# Wellington City Council Proposed District Plan Hearing Stream 4 – Centres

## Zone Recommendations

To assist the presentation of Evidence of N.Rae  
20/06/2023

# Tawa TCZ

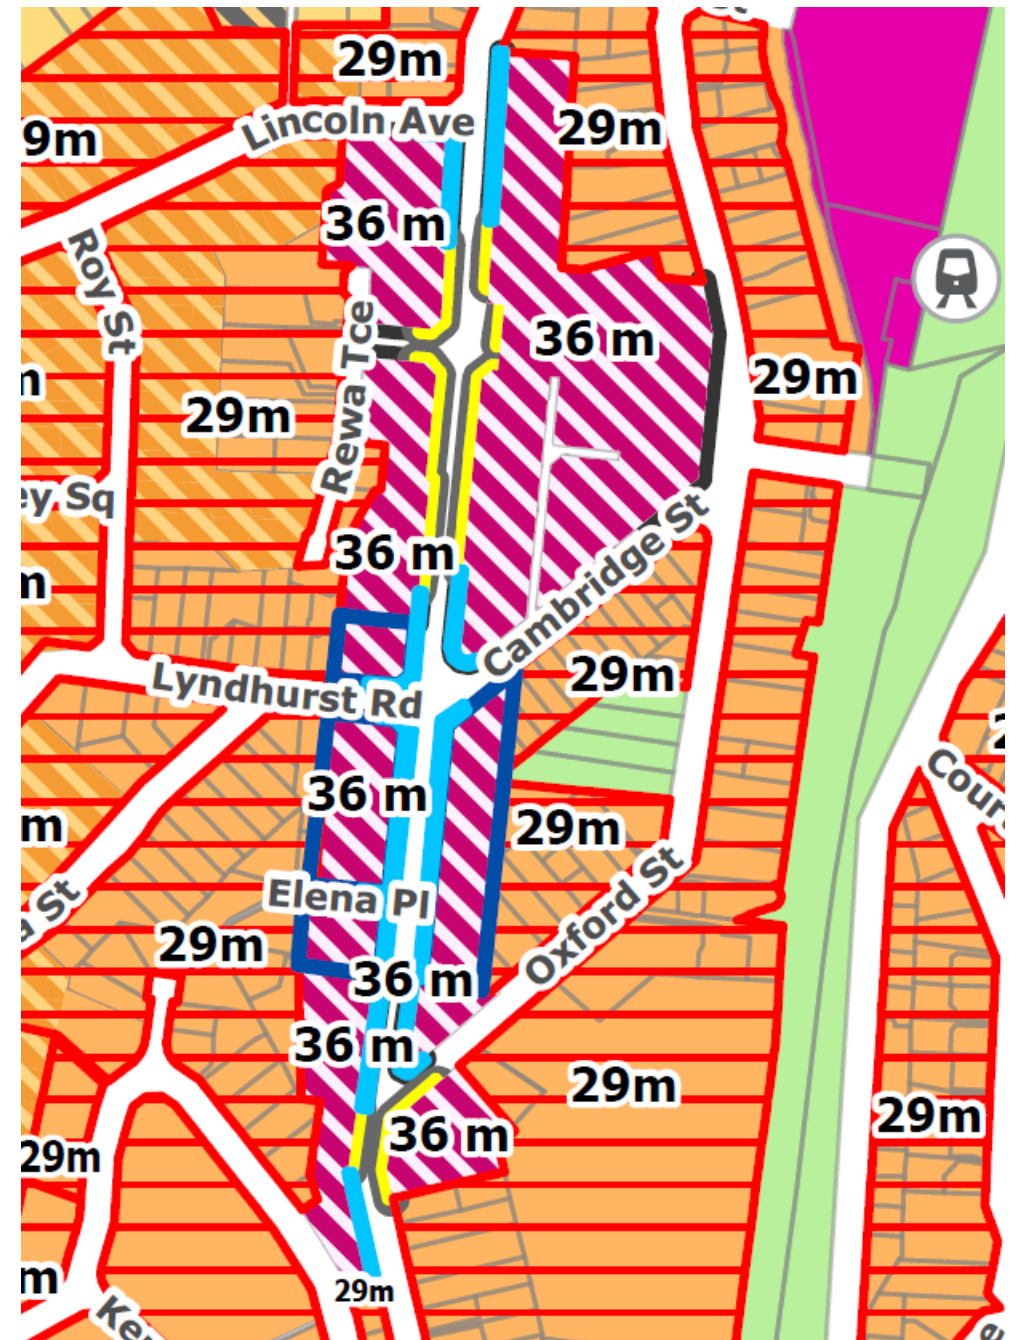
- **Position:** Support Kāinga Ora submission to expand TCZ as illustrated by area contained within dark blue line to link the two existing NCZ and LCZ.
- **Recommended Changes:** Extend verandah and active frontage controls to frontage with blue line on map.
- **Comments:**
  - This provides a longer ‘high street’ type town centre with good development opportunities and manages the interface at ground level to encourage a more interesting, active, and safe pedestrian experience.
  - 10 Storeys in the centre provides for growth on a limited land area, and supports identification of the centre through taller buildings with 8 storeys surrounding (as recommended in HS2).

# Newlands LCZ

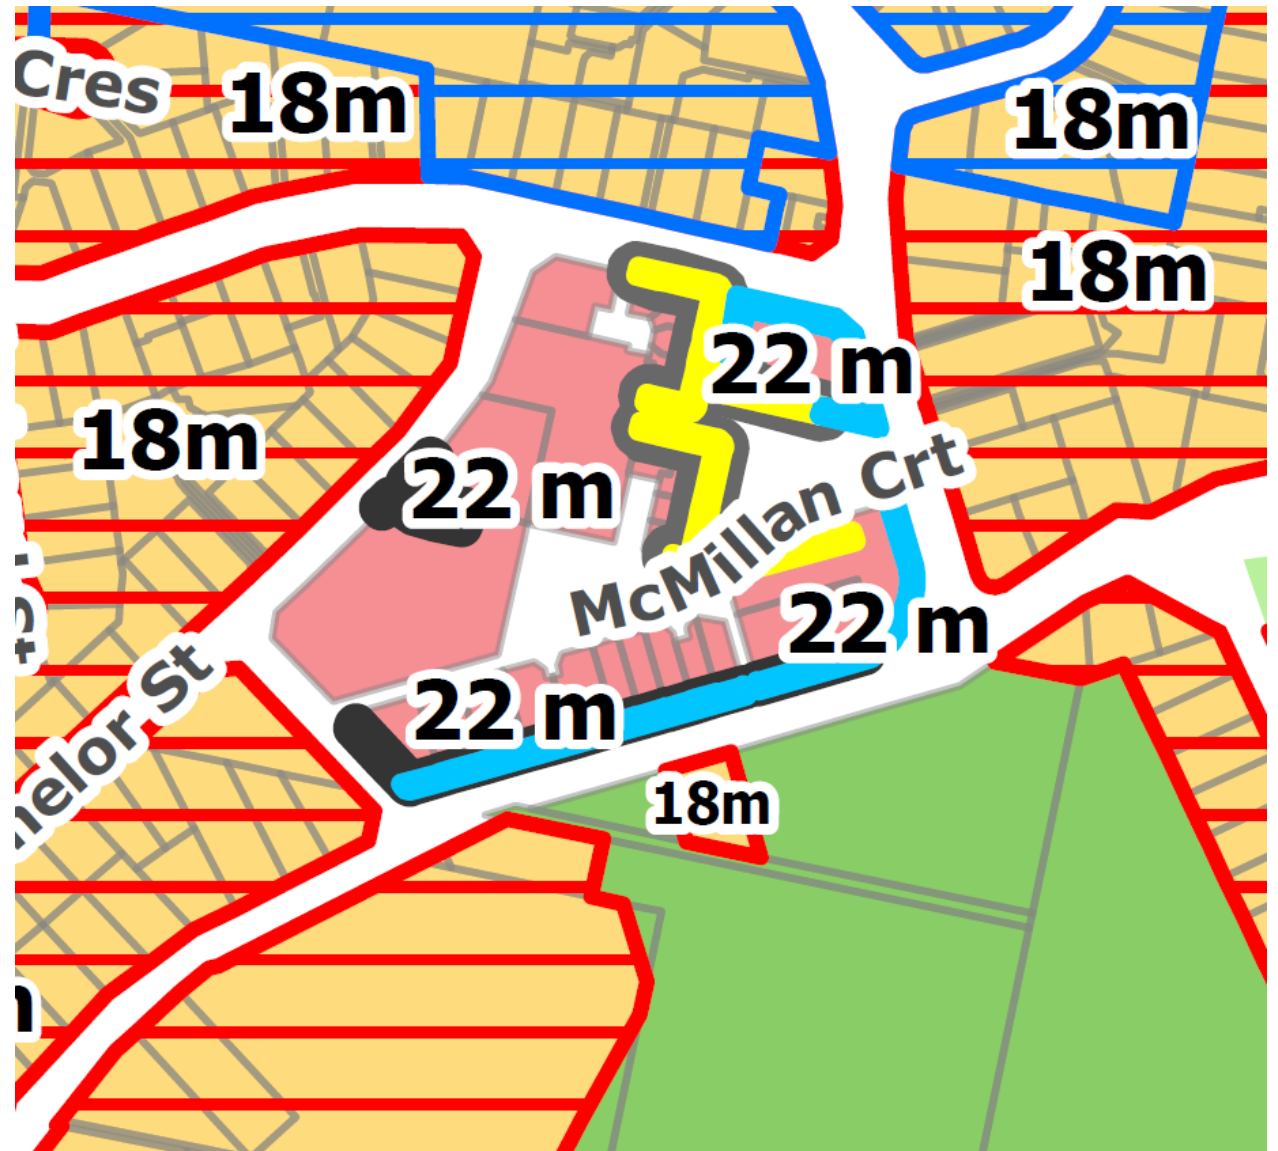
- **Position:** Support LCZ and height – no zone change
- **Recommended changes:** Extend verandah and active frontage control as per blue line to encourage activation of the street frontage of the centre, in addition to its internal focus.
- **Comment:** The LCZ is opposite an open space with a play ground and an active edge is desirable in this location to assist with the amenity and safety of the location.

# Johnsonville MCZ

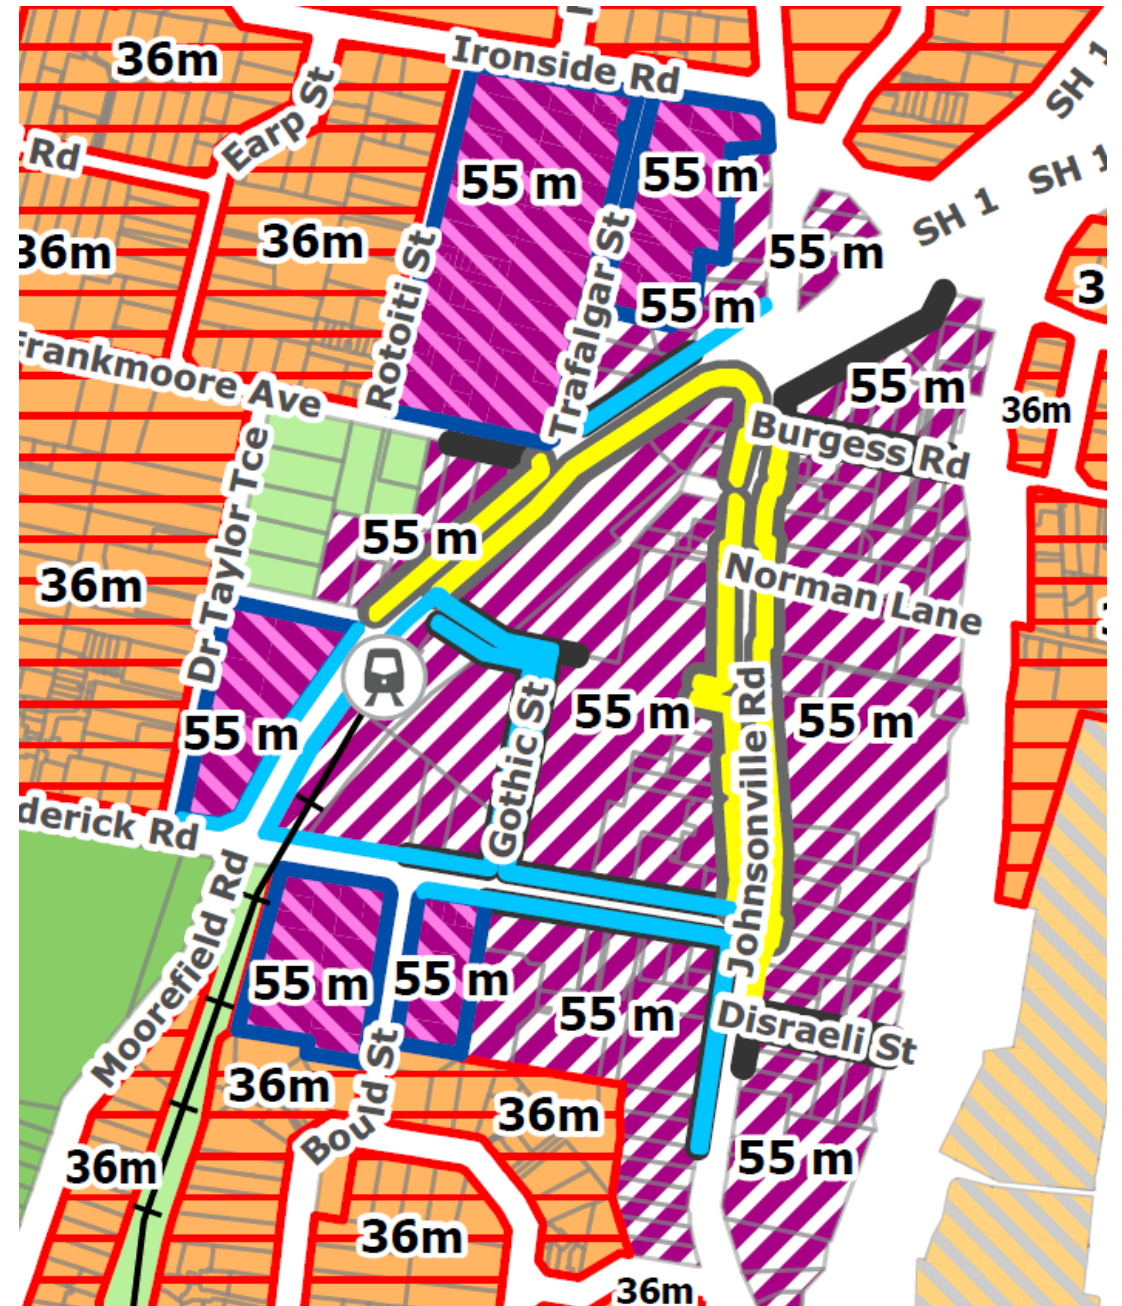
- **Position:** Support MCZ
- **Recommended changes:** Expand MCZ to areas contained within dark blue line to provide greater opportunity for a greater mix of activities, and manage street interface outcomes and amenity issues to assist with creating a well-functioning centre
- Apply a 55m height standard in MCZ as this provides for 15 storeys providing good development opportunities in centre without significant adverse effects
- Extend verandah and active frontage control as per blue line to encourage a high amenity outcome for the full length of streets as key public places in the centre, particularly Moorefield Road supporting existing community facilities

# Karori Centre LCZ

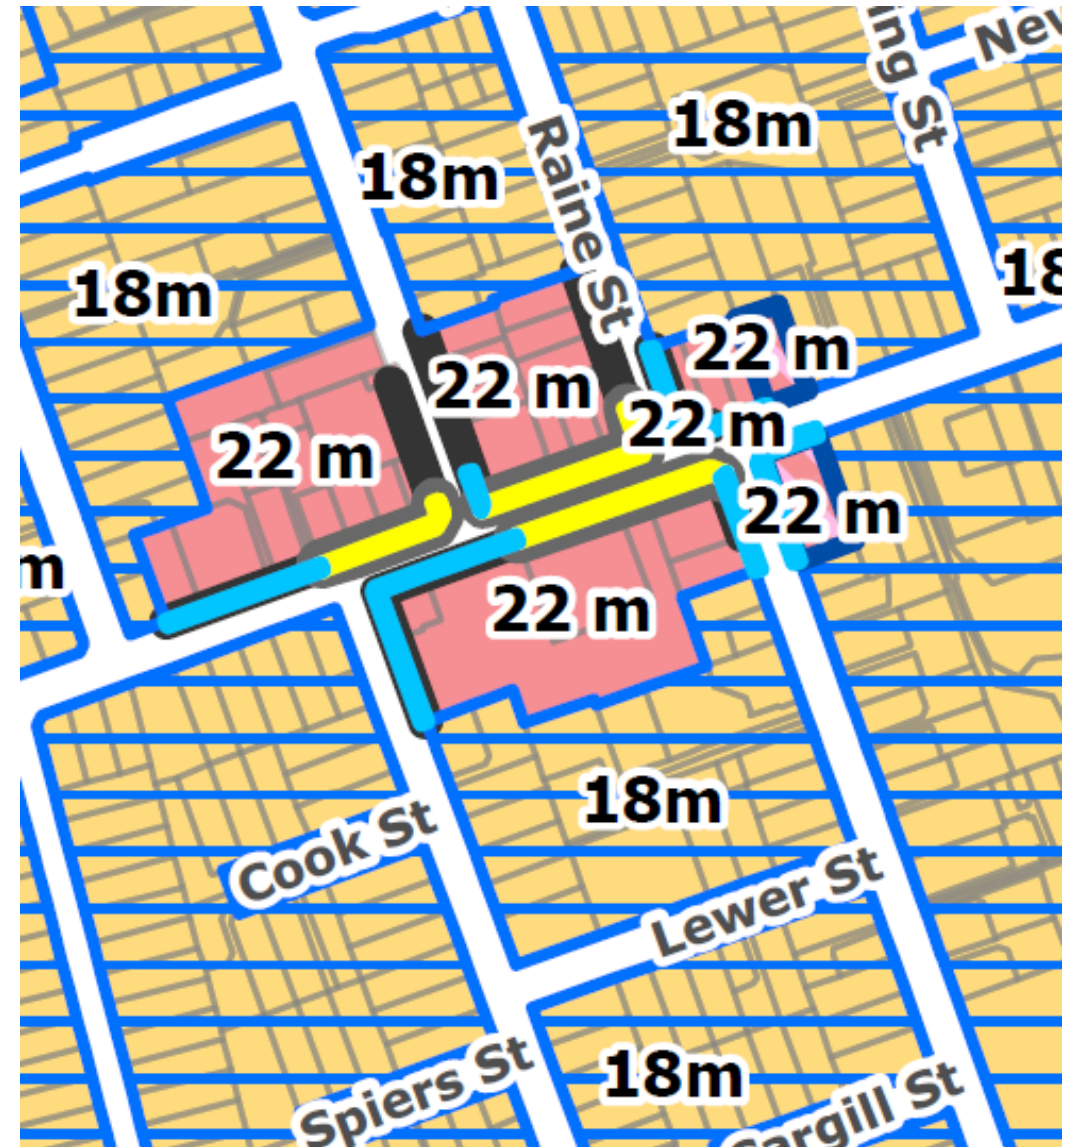
- **Position:** Support LCZ and height 22m and partially support Kāinga Ora's submission to expand Karori centre within dark blue line.
- **Recommended changes:** Expand verandah and active frontage controls as per blue line to enhance pedestrian amenity and vibrancy of the centre.
- **Comment:** expansion to enable a more suitable built form at this intersection at a key arrival point into the centre.
- Do not support centre expansion to connect Karori with Marsden Centre at this time.
- Consider other employment opportunities in a separate process.

# Marsden Centre LCZ

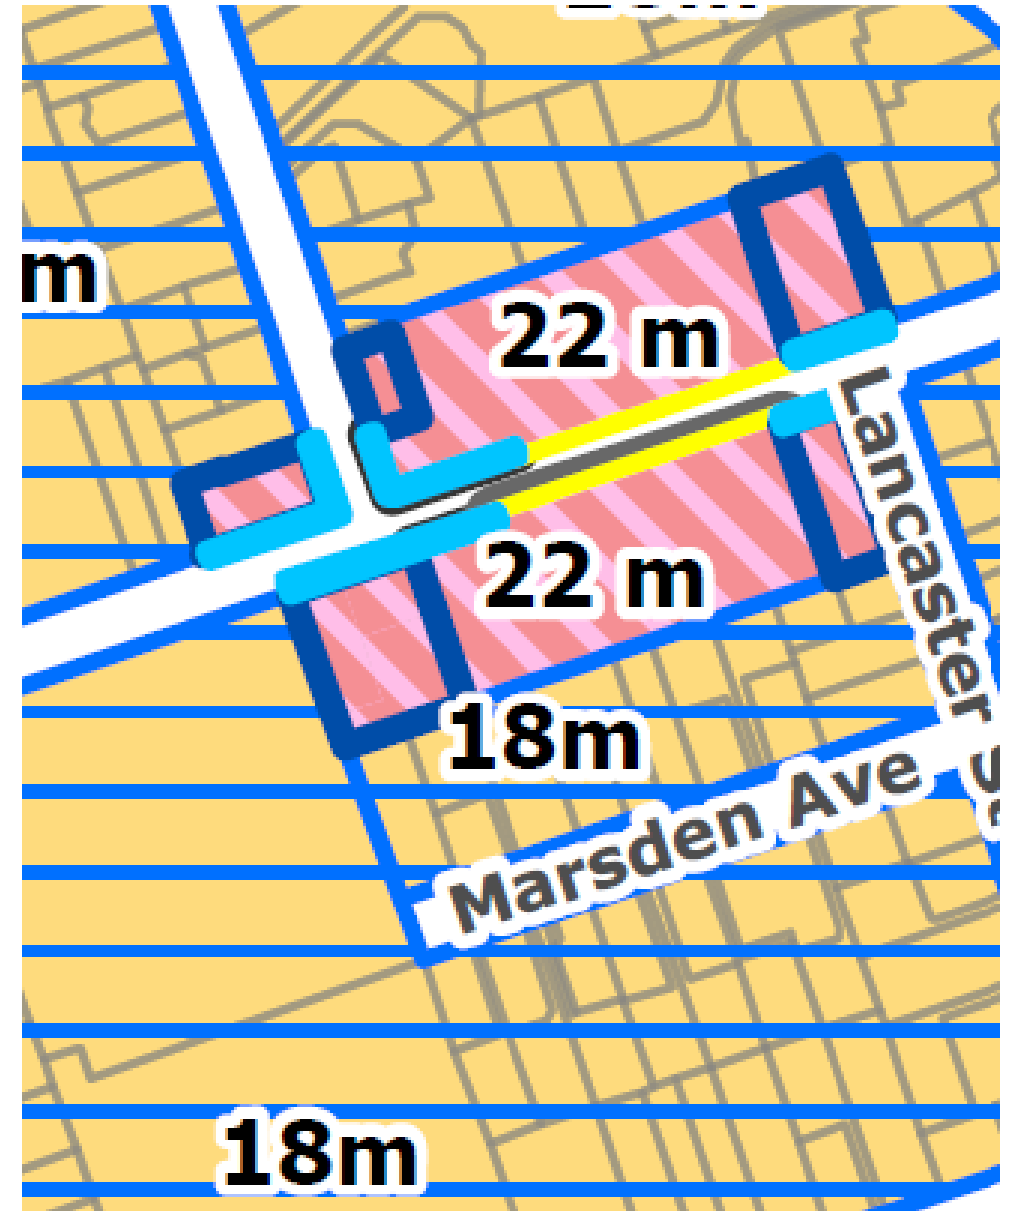
- **Position:** Support Kāinga Ora submission to change NCZ to LCZ and expand LCZ only within dark blue line at Marsden Village with the resulting increase in height to 6 storeys .
- **Recommended changes:** Extend the verandah and active frontage controls as per blue line to enhance pedestrian amenity
- **Comment:** Expansion to include street corners & avoid residential only at ground floor between centre and school / church to the west
- 22m will provide some greater opportunity managed with HIRB at residential interface.
- Church and school to west could also be zoned LCZ but not essential.

# Brooklyn LCZ

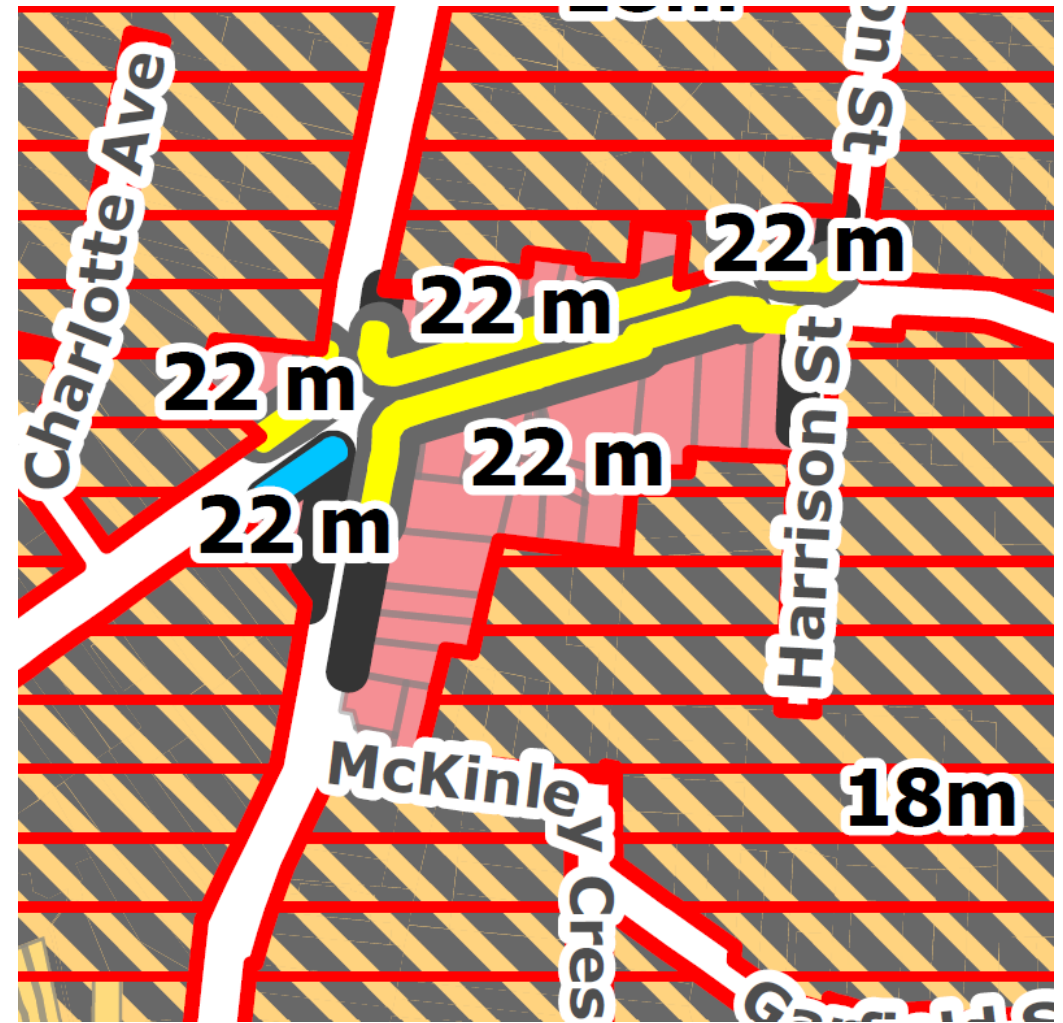
- **Position:** Support LCZ and height 22m
- **Recommended changes:** Extend verandah and active frontage control as per blue line to ensure retention of existing amenity
- **Comment:** Do not support centre expansion in Kāinga Ora submission to north of centre (not illustrated)

# Newtown (nth) TCZ

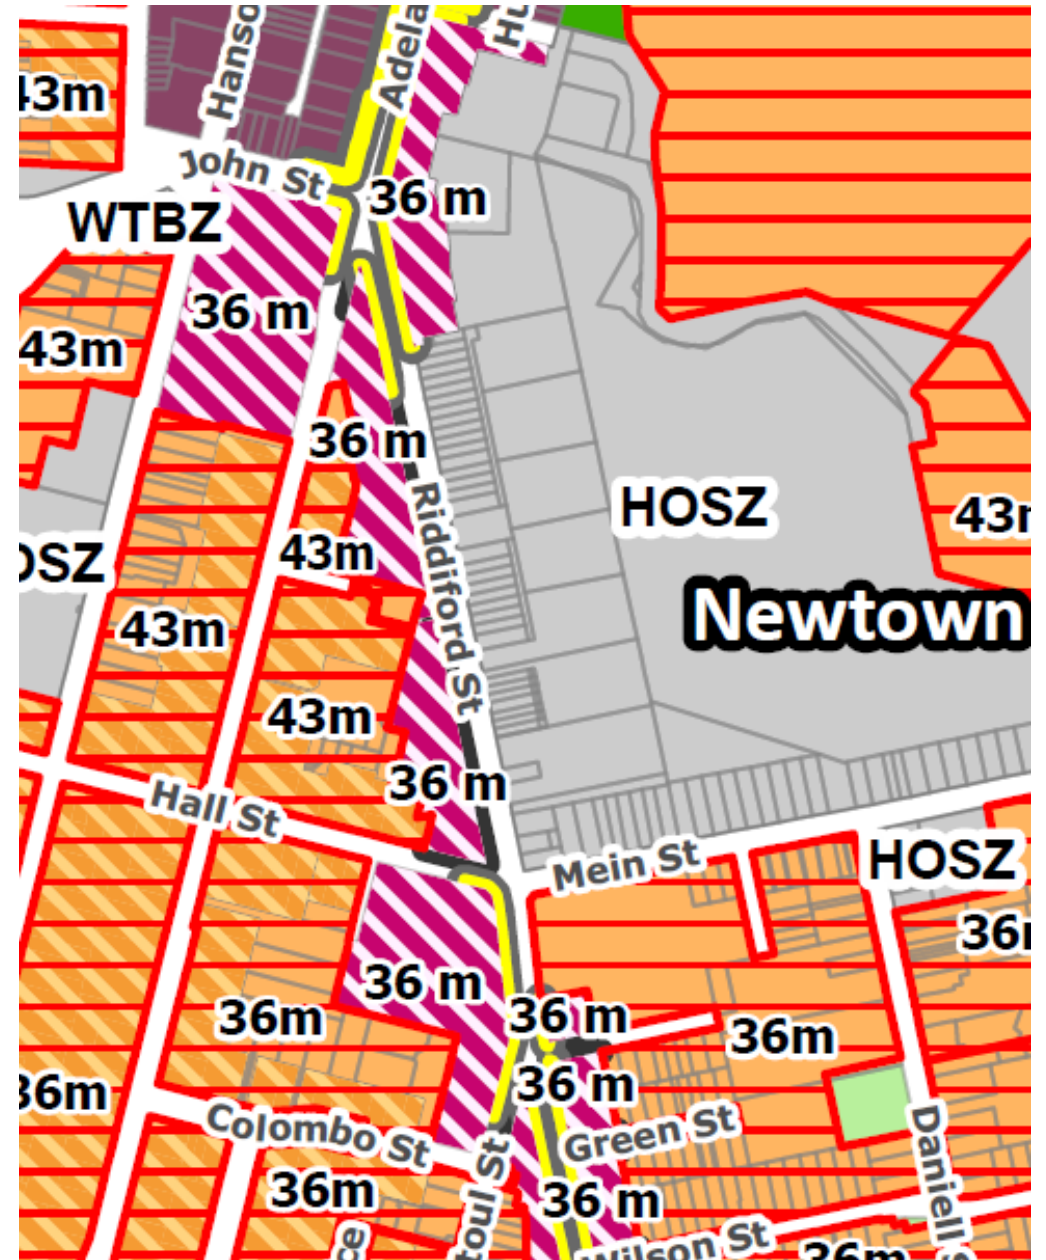
- **Position:** Support Kāinga Ora's submission to change zone from LCZ to TCZ, and support increased height standard to 36m – 10 storeys
- **Recommended changes:** Extend verandah and active frontage control as per blue line
- **Comment:** to ensure enhanced pedestrian amenities along this 'high street' centre
- TCZ appropriate in context of the CCZ, hospital and consistent with the expectation of an inverted height outcome where centre will be lower than surrounding HRZ (overlays).
- Height will be managed with HIRB to HRZ zone

# Newtown (sth) TCZ

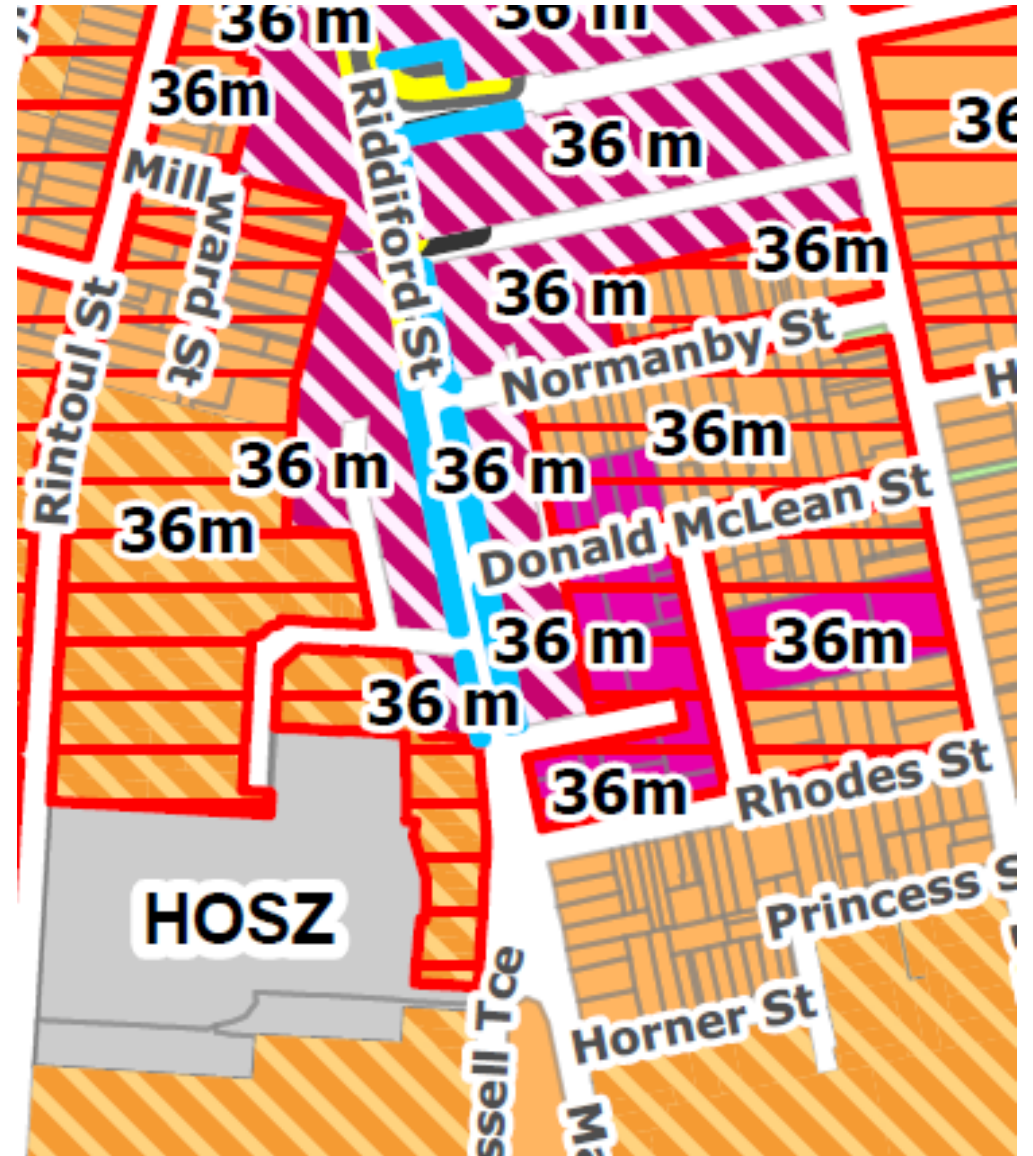
- **Position:** Support Kāinga Ora's submission to change zone from LCZ to TCZ, and support increased height standard to 36m – 10 storeys
- **Recommended changes:** Recommend MUZ same height as HRZ surrounding.
- Extend active frontage and verandah controls at blue line, including to apply open spaces such as pocket park north of Constable Street
- **Comment:** Expectation of lower centre at Constable street intersection part of northern area. Good opportunities to the south and east along Constable Street. HIRB of HRZ to manage height at interface
